HANDS OF HOPE HEALTH CARE SUBDIVISION

APPLICATION NUMBER 6 DATE July 7, 2016

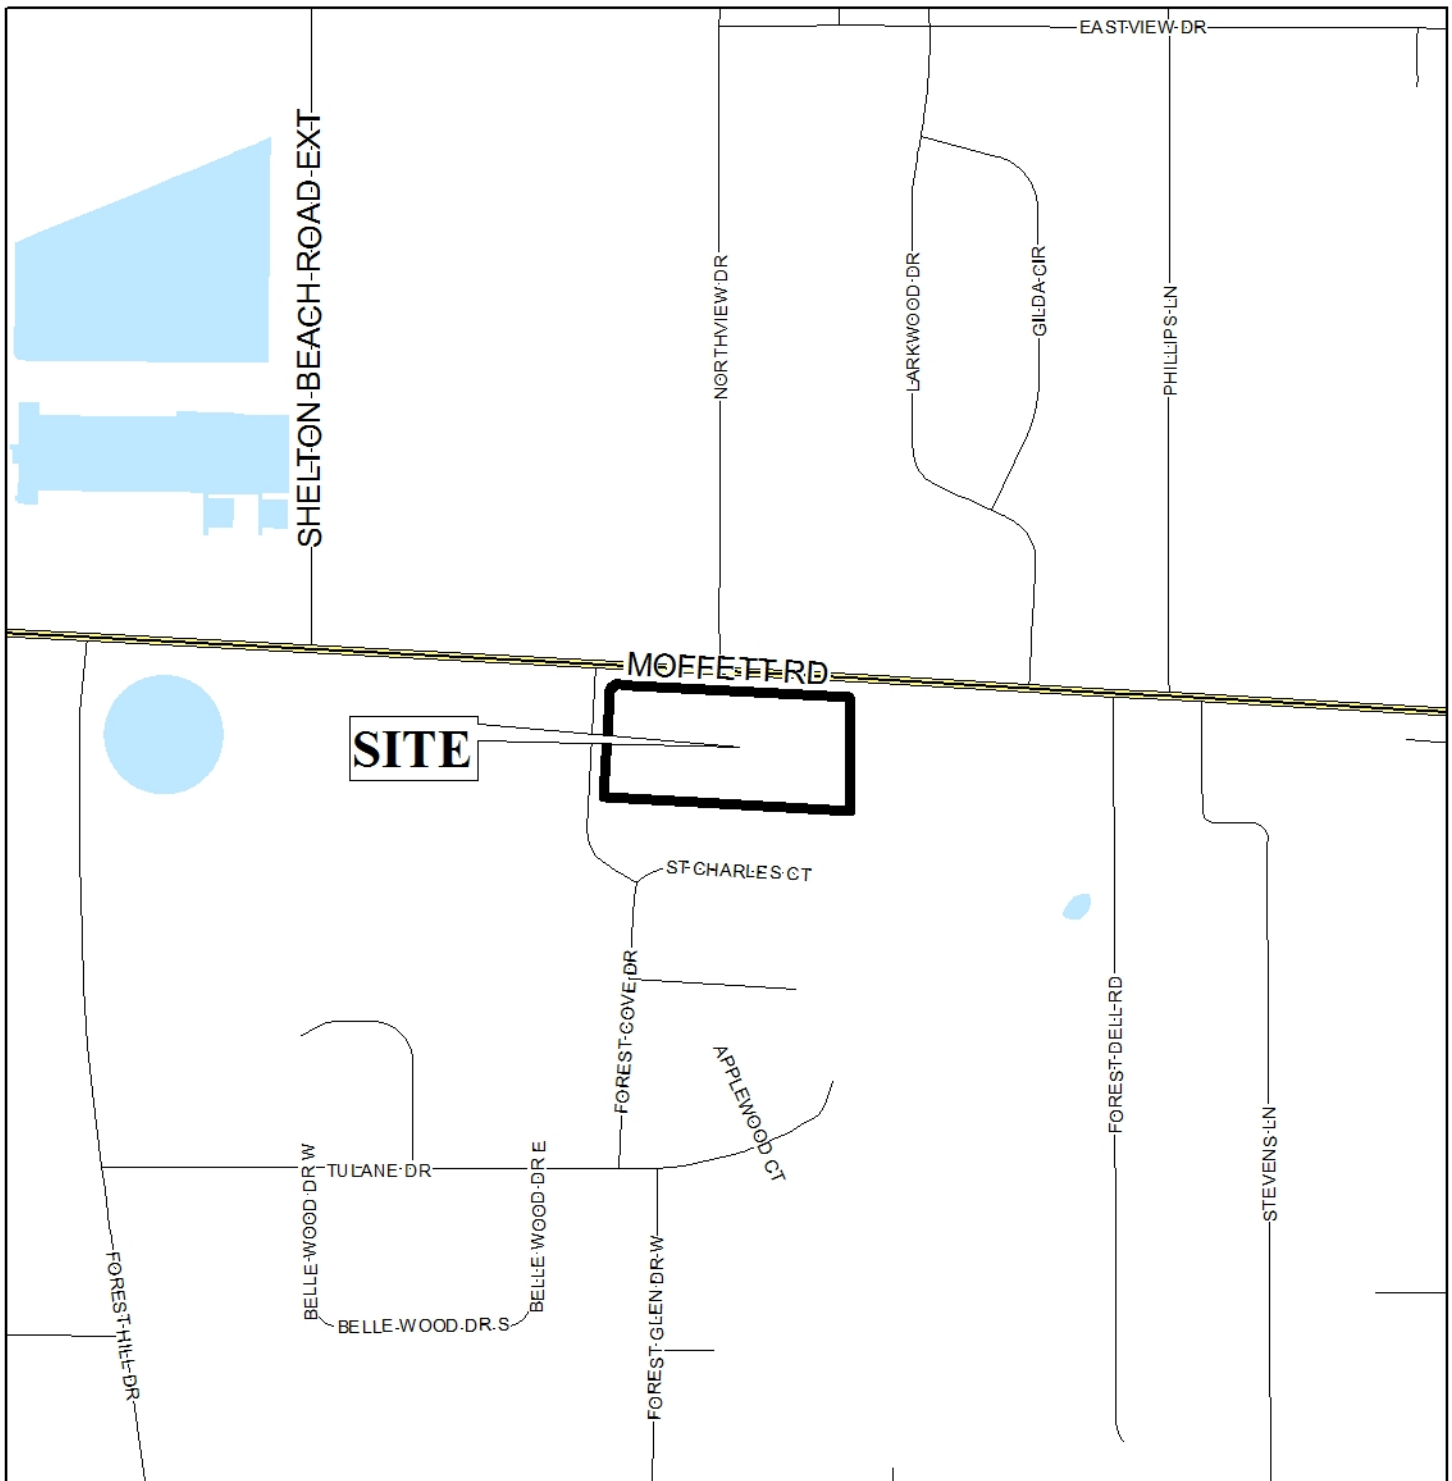
- A. Provide all of the required information on the SUBDIVISION PLAT (i.e. signature blocks, signatures, certification statements, written legal description, required notes, legend, scale, bearings and distances) that is required by the current Alabama State Board of Licensure for Professional Engineers and Land Surveyors.

- B. Clarify the Site Location within the Vicinity Map.
- C. Label the existing lot information on the west side of Forest Cove Dr. to clarify the POC.
- D. Provide the tie distance/bearing from the POC to the POB.

- E. Review and revise the written legal description for the curve data (delta angle info) and remove the “?” from the following “...SAID POINT BEING THE P.C.?...”.

- F. Provide and label the monument set or found at each subdivision corner.
- G. Provide the Surveyor’s, Owner’s (notarized), Planning Commission, and Traffic Engineering signatures.

- H. Add a note to the SUBDIVISION PLAT stating that a Land Disturbance permit will be required for any land disturbing activity in accordance with Mobile City Code, Chapter 17, Storm Water Management and Flood Control); the City of Mobile, Alabama Flood Plain Management Plan (1984); and, the Rules For Erosion and Sedimentation Control and Storm Water Runoff Control.

- I. Add a note to the Plat stating that the approval of all applicable federal, state, and local agencies (including all storm water runoff, wetland and floodplain requirements) will be required prior to the issuance of a Land Disturbance permit.

- J. Add a note that sidewalk is required to be constructed, and/or repaired, along the frontage of each lot, or parcel, at time of new development or construction, unless a sidewalk waiver is approved.

- K. Remove the County Engineering Department statement from the Plat. The County Engineer no longer signs plats within the municipal limits of the City of Mobile.

The site fronts onto Moffett Road with a compliant 100' right-of-way, and Forest Cove Drive with a compliant 50' right-of-way. A compliant 25' corner radius is also indicated along the right-of-way. Therefore, no dedication would be required. Moffett Road is US Highway 90 and is thus, under the purview of ALDOT. ALDOT is implementing a street access management plan for highways and may be more restrictive than the City of Mobile standards. As a means of access management, each lot should be limited to one curb cut to Moffett Road, with the driveway size, location and design to be approved by Traffic Engineering and ALDOT, and conform to AASHTO standards. Lot 1 should be denied access to Forest Cove Drive.

Each lot meets the minimum area and width requirements of the Subdivision Regulations. As on the preliminary plat, the Final Plat should also label each lot with its size in both square feet and acres, or a table should be furnished on the Final Plat providing the same information. And as on the preliminary plat, the 25' minimum building setback line should also be illustrated on the Final Plat along both street frontages.

The plat meets the minimum requirements of the Subdivision Regulations and is recommended for tentative approval, subject to the following conditions:

- 1) placement of a note on the Final Plat stating that each lot is limited to one curb cut to Moffett Road, with the size, location and design to be approved by Traffic Engineering and ALDOT, and conform to AASHTO standards, or as directed by ALDOT;

- 2) placement of a note on the Final Plat stating that Lot 1 is denied direct access to Forest Cove Drive, or as directed by ALDOT;
- 3) retention of the lot size labels in both square feet and acres, or the furnishing of a table on the Final Plat providing the same information;

- 4) retention of the 25' minimum building setback line along both street frontages on the Final Plat;
- 5) subject to the Engineering comments: *[The following comments should be addressed prior to submitting the FINAL PLAT for acceptance and signature by the City Engineer: A. Provide all of the required information on the SUBDIVISION PLAT (i.e. signature blocks, signatures, certification statements, written legal description, required notes, legend, scale, bearings and distances) that is required by the current Alabama State Board of Licensure for Professional Engineers and Land Surveyors. B. Clarify the Site Location within the Vicinity Map. C. Label the existing lot information on the west side of Forest Cove Dr. to clarify the POC. D. Provide the tie distance/bearing from the POC to the POB. E. Review and revise the written legal description for the curve data*
